City of Portland, Maine – Building or Use Permit Application 389 Congress Street, 04101, Tel: (207) 874-8703, FAX: 874-8716

Location of Construction: 38 Cushman Street, 04102		Owner: Margaret & Mark Hollings		Phone: 781-8385	Permit No: 000523	
Owner Address: 38 Cushman Street, 04102		Lessee/Buyer's Name:		Phone: 892-6335		
Contractor Name: John Merrill Builders		Address: 131 Roosevelt Trail, 04093		Phone: 892-6335	Permit Issued: MAY 19 2000 DEPT. OF BUILDING INSPECTION CITY OF PORTLAND, ME	
Past Use: multi		Proposed Use: SAME		COST OF WORK: \$ 3,000.00		
Proposed Project Description: Replace existing deck in rear and add windows.		Signature: [Signature]		PERMIT FEE: \$ 42.00	Zone: CBL	
				FIRE DEPT. <input type="checkbox"/> Approved <input type="checkbox"/> Denied		INSPECTION: Use Group: 92 Type: 53
				PEDESTRIAN ACTIVITIES DISTRICT (P.A.D.)		
				Action: <input type="checkbox"/> Approved <input type="checkbox"/> Approved with Conditions <input type="checkbox"/> Denied		
Permit Taken By: GD		Date Applied For: MC 5-08-2000		Signature: [Signature] Date: [Blank]

We want to remove the existing enclosed back porch off of the first floor, which is 4'x12' see Photo A, B, and D. In it'

Design 2
(Inside View)

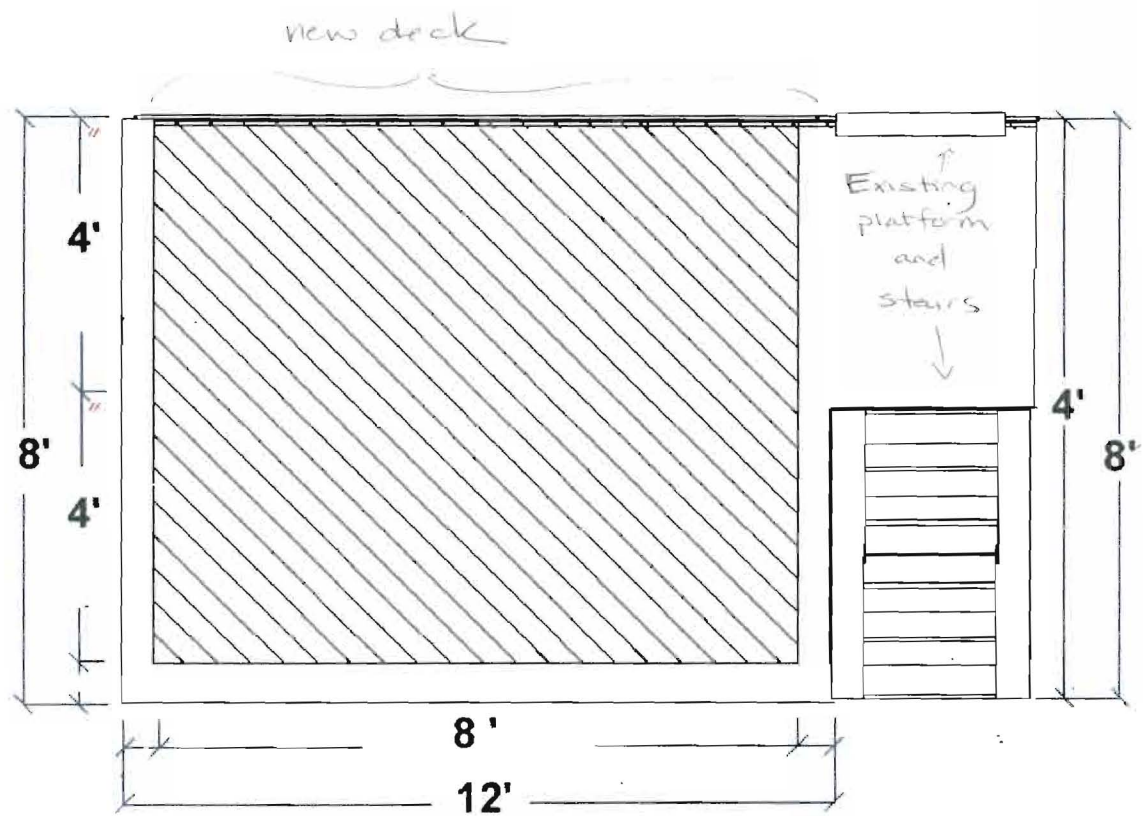
X 37. Your plan did not show header size for the proposed windows please submit this detail before work begins

Design 1

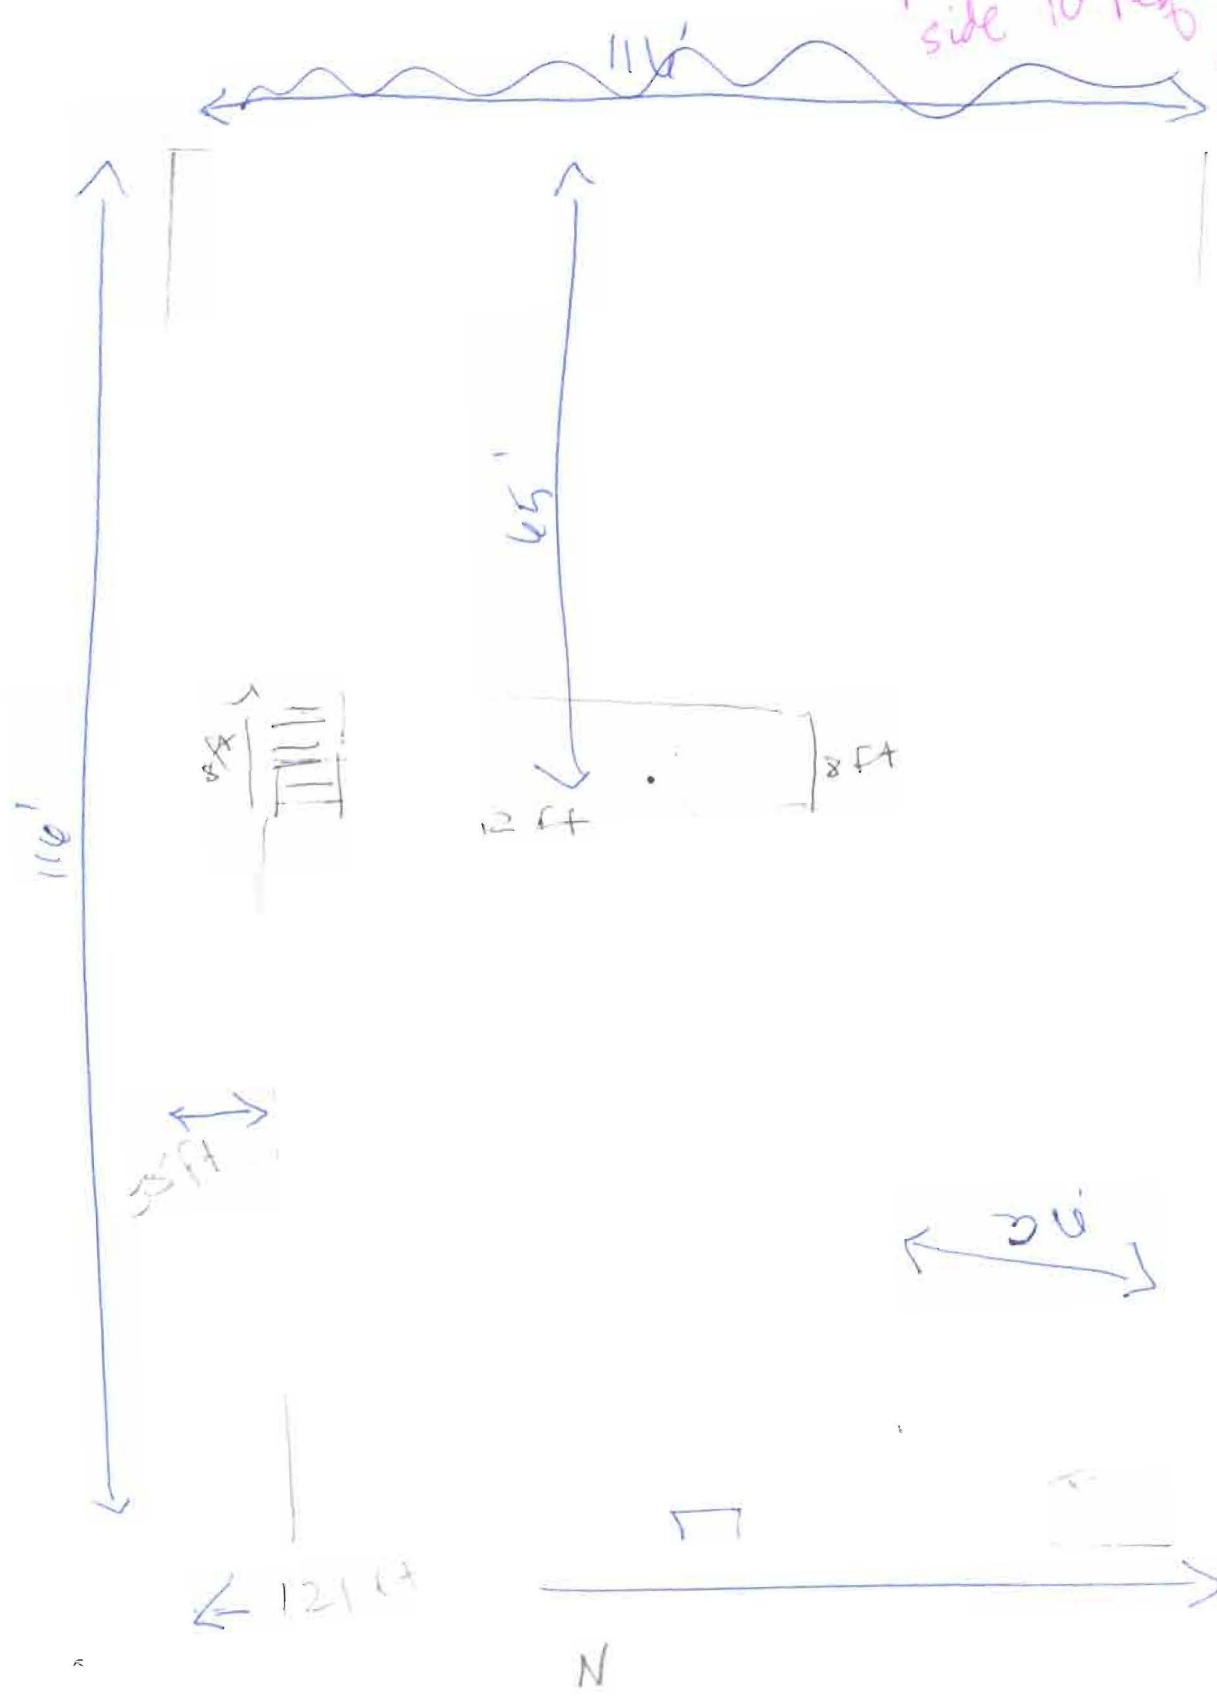
Change in Stairway location - instead of off the Rear they enter the Driveway side. Needs Graopable Hand Rail. JB

Windows same as 2nd Floor 5-2' windows w/ Mullions JB
3/19/02 Graopable Rail installed JB
